## **Stormwater Detention and Infiltration Design Data Sheet**

Stormwater Facility Name: RocKy Top Resources

Facility Location & Jurisdiction: El Paso County Colorado

**Routed Hydrograph Results**

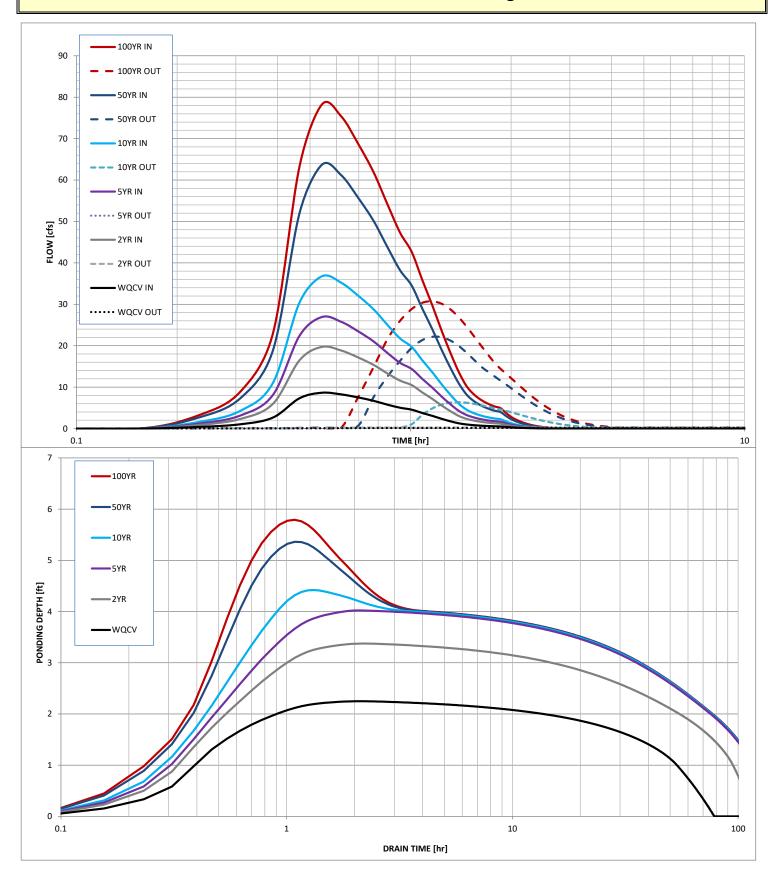
This doesn't match your design.

Be advised this isn't meeting the senate bill
